Subject: Submittal of the Response to the Notice of Disapproval Baseline Geomorphic Conditions at Sediment Transport Mitigation Sites in Los Alamos/Pueblo Canyon Watersheds and Revision 1

**Response to the Notice of Disapproval for the Report on Baseline Geomorphic Conditions at
Sediment Transport Mitigation Sites in the Los Alamos and Pueblo Canyon Watersheds
Los Alamos National Laboratory EPA ID No: NM0890010515, HWB-LANL-08-004,
Dated January 31, 2011**

Baseline Geomorphic Conditions at Sediment Transport Mitigation Sites in the Los Alamos and Pueblo Canyon Watersheds, Revision 1

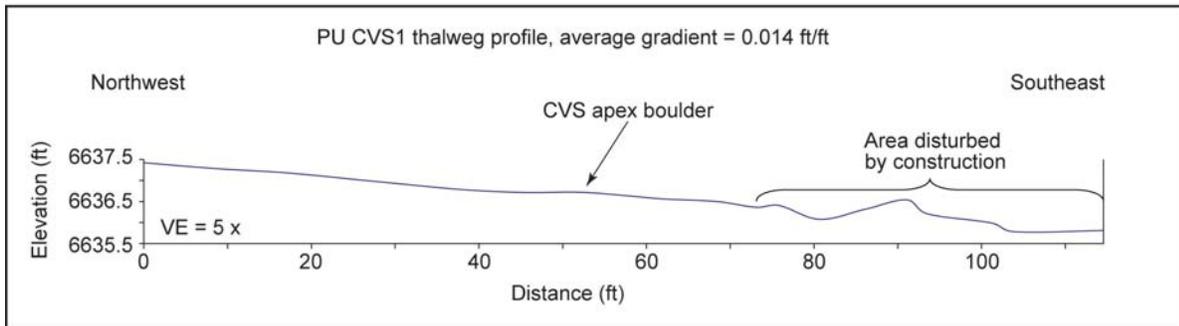
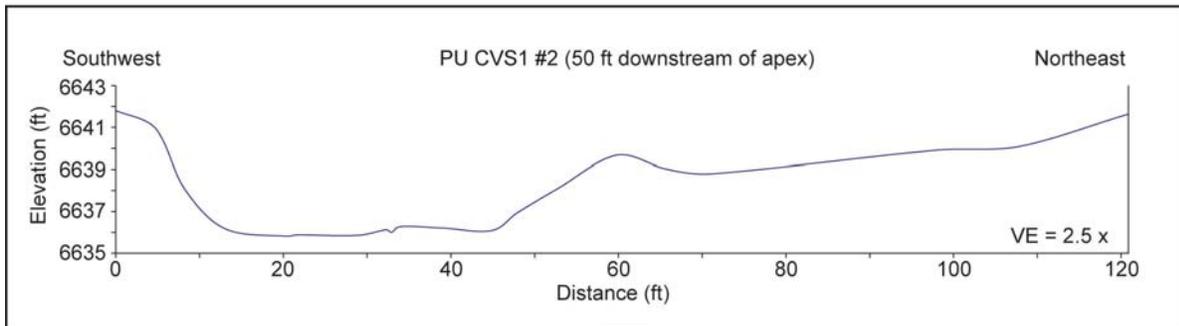
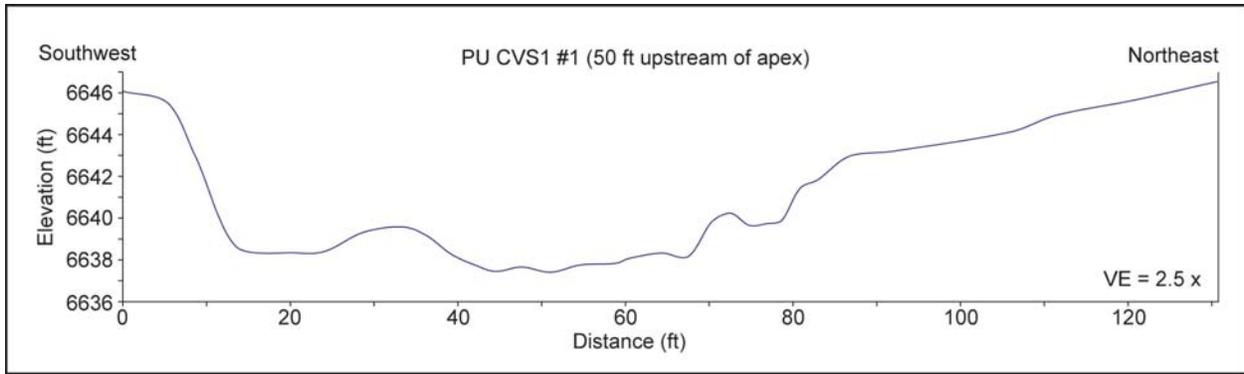
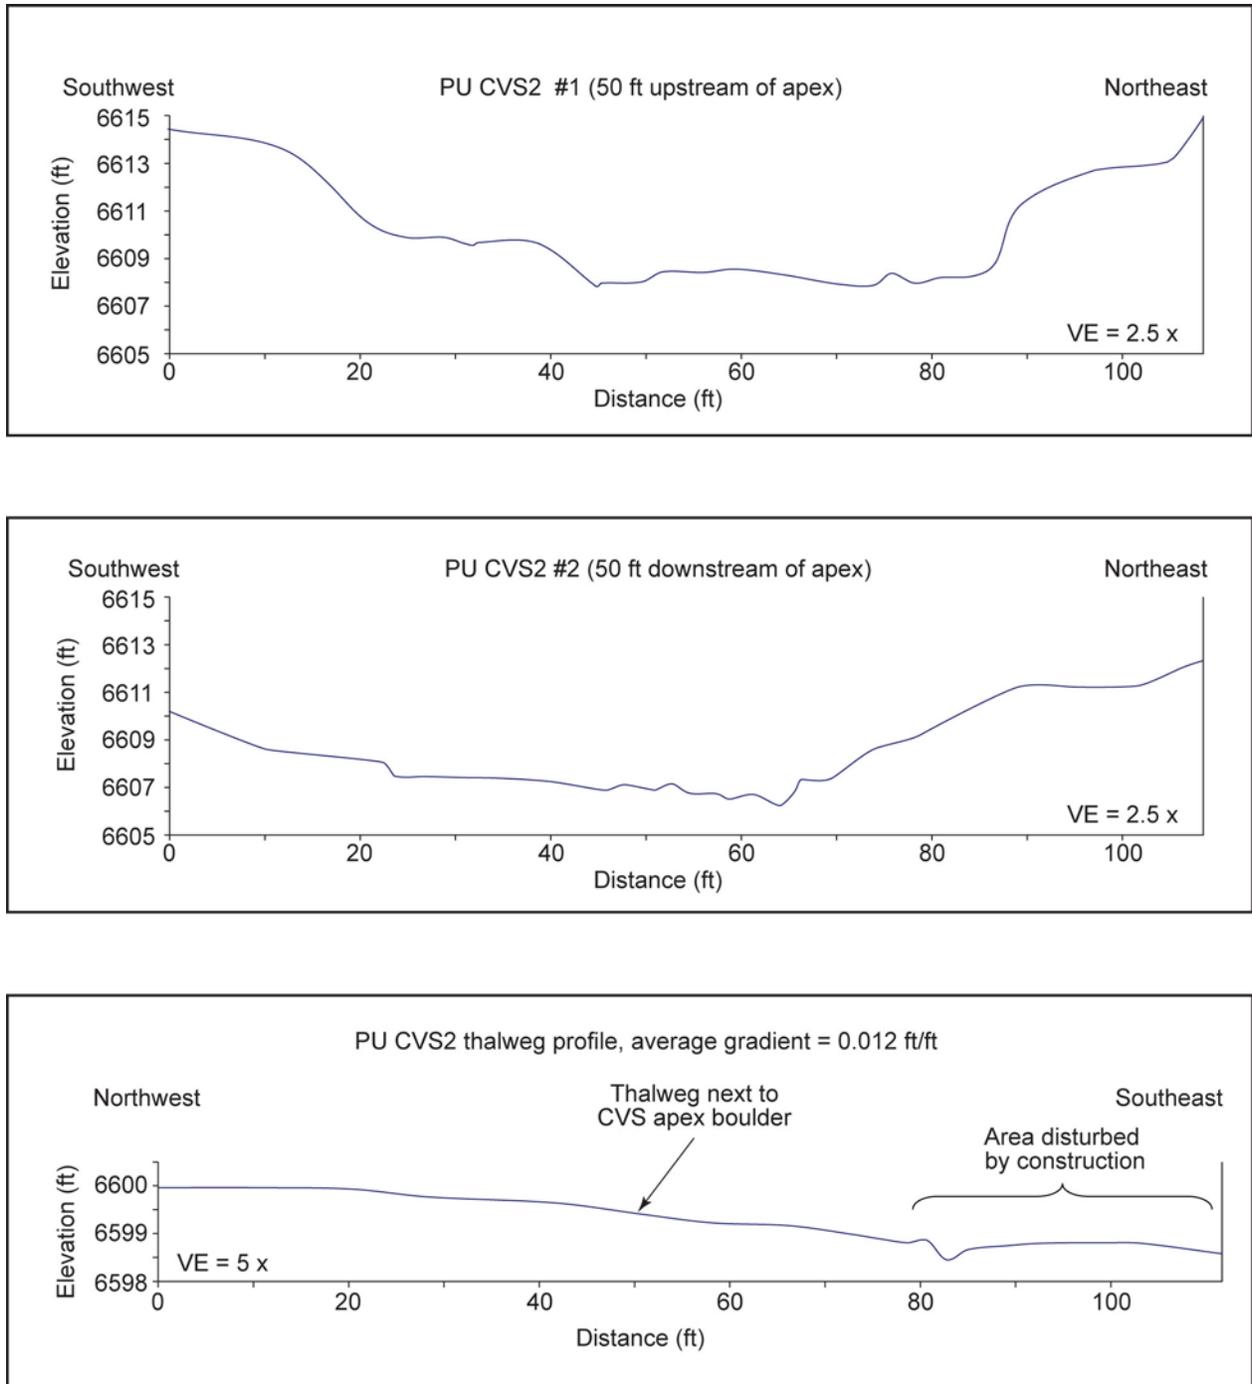
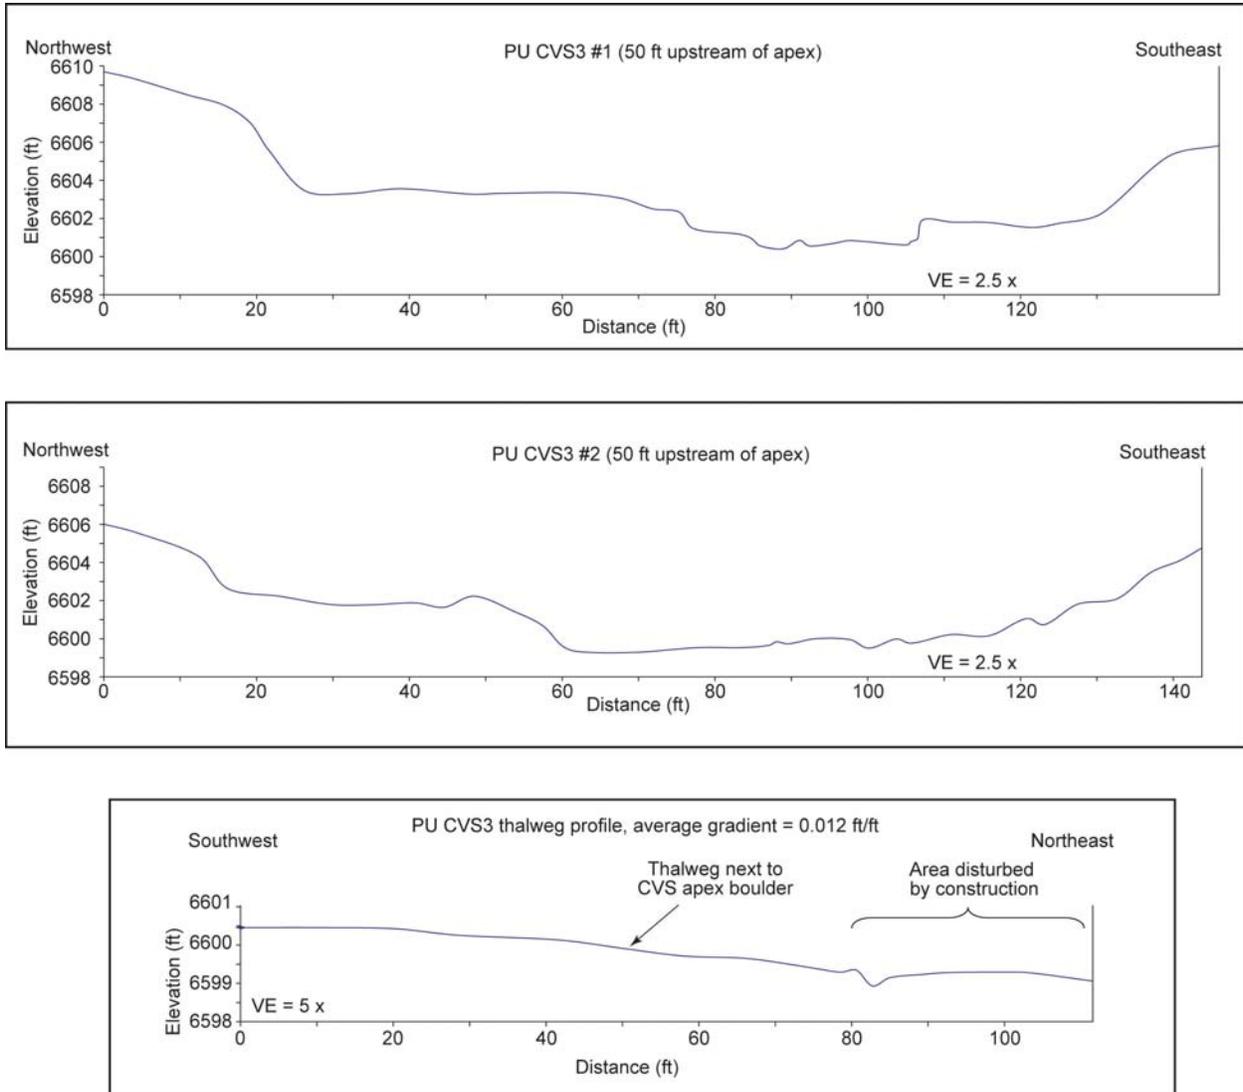
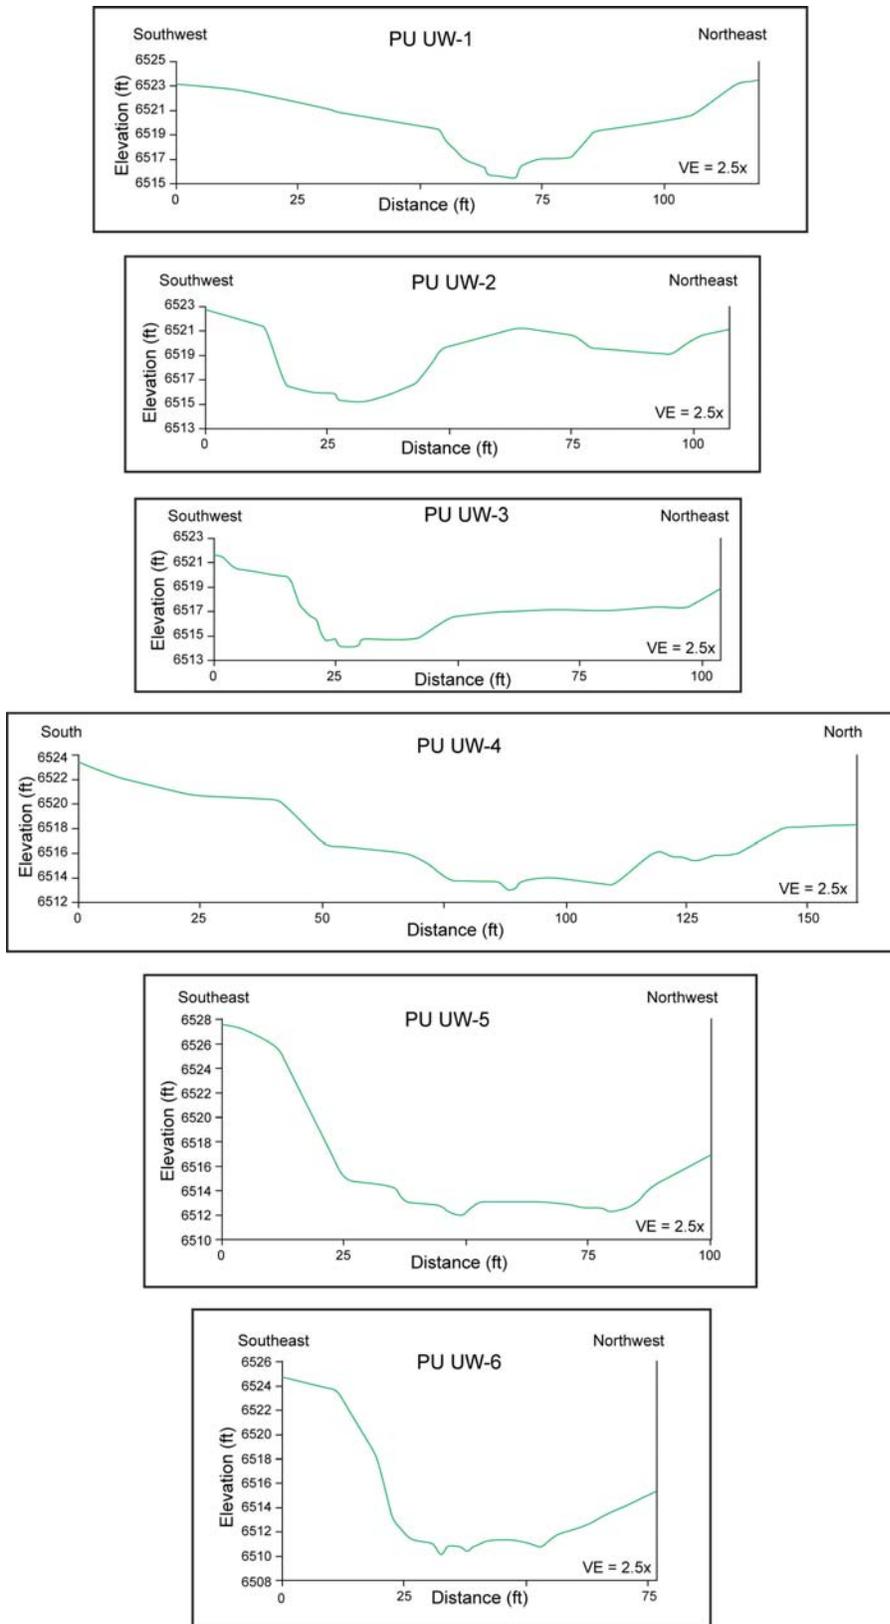
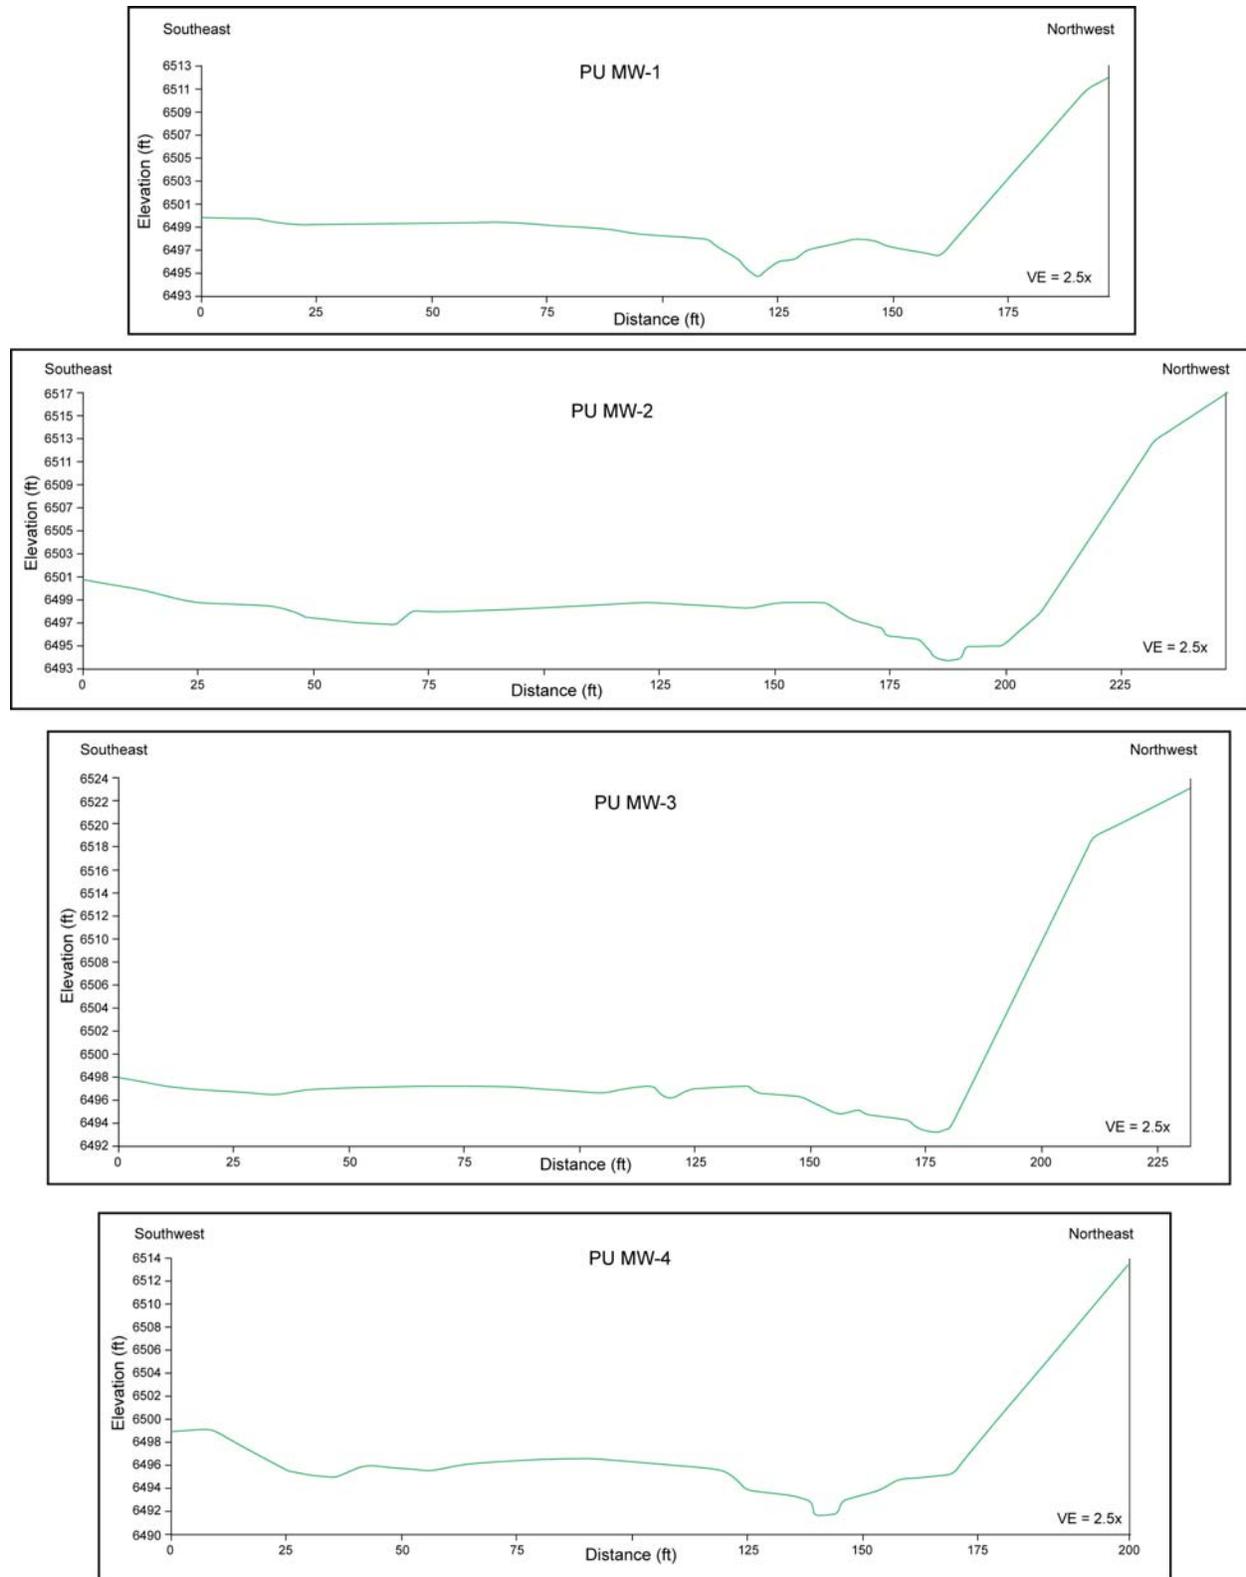
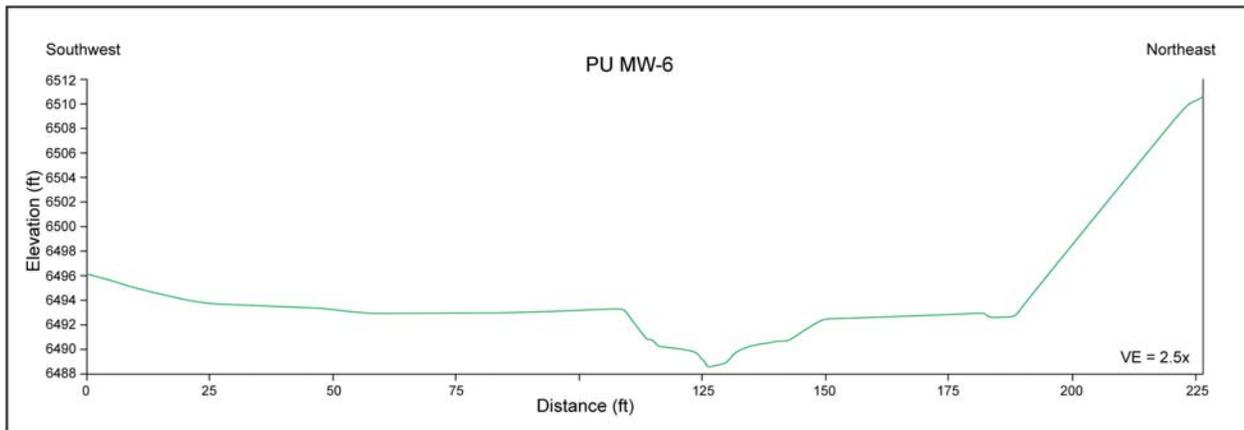
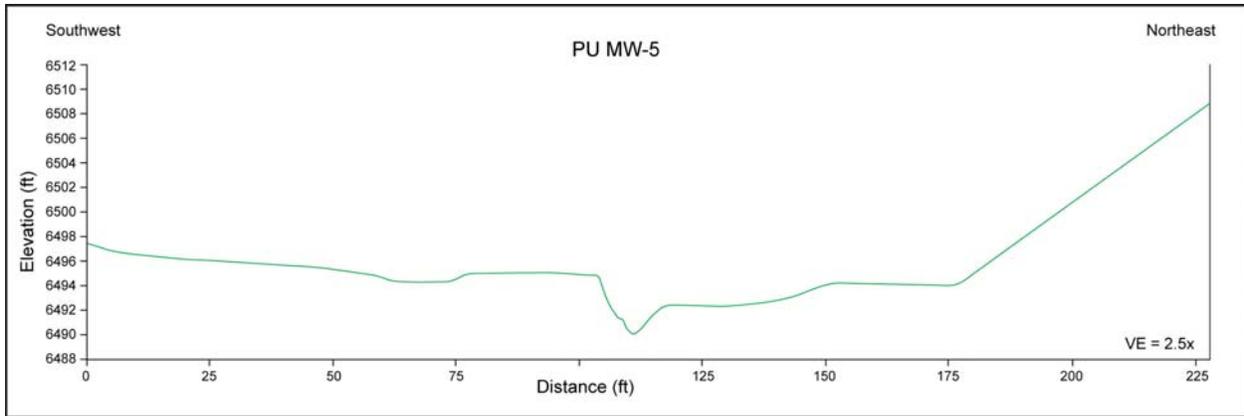
2. *Figures 3, 4, 5, 7, 8, 9, 10, 12, 13, 15, 16, 18, 19, 22, and 23 consist of multiple 2-dimensional graphs, with elevation on the Y axis and distance on the X axis, depicting cross sections and thalweg profiles. The survey data used to generate the graphs were provided by the Permittees in Attachment 1. According to the Permittees, a "Geodimeter 620 total station survey method" was employed to generate the graphs. NMED could not interpret the coordinates provided in Attachment 1 or reproduce the graphs as depicted in Figures 3, 4, 5, 7, 8, 9, 10, 12, 13, 15, 16, 18, 19, 22, and 23. Provide the data in a format that can be used by NMED to reproduce the graphs and evaluate the cross sectional features.*

2. The survey data were obtained using either a total station or a global positioning system and used the New Mexico State Plane coordinate system. Graphs were prepared using Excel software after first converting the x and y coordinates to distance from the end of each section or profile. This conversion involved basic trigonometry (Pythagorean theorem). Columns have been added to the tables in Attachment 1 showing the calculated distances along each section or thalweg profile for each survey point (excluding benchmarks). The text has also been revised to describe this conversion.
